Access Compliance Report

Public Rights-of-Way

(Curb Ramps)

Intersection ID: 27792	Main Street: BLAKENEY_HEATH_RD	Cross Street: PARKS_FARM_LN	Location: SW
ADA ID: C898C785CC3A	Ramp Type: BlendTrans1	Initial Pass/Fail: Fail	Overall Compliance: No
		Severity Score: 8.75

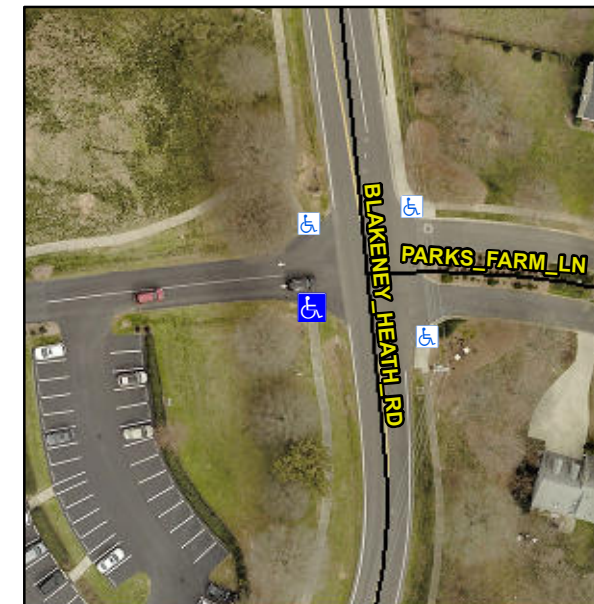
R304.5.1

Remove & Replace Curb Ramp With Two New Directional Ramps or Equivalent.
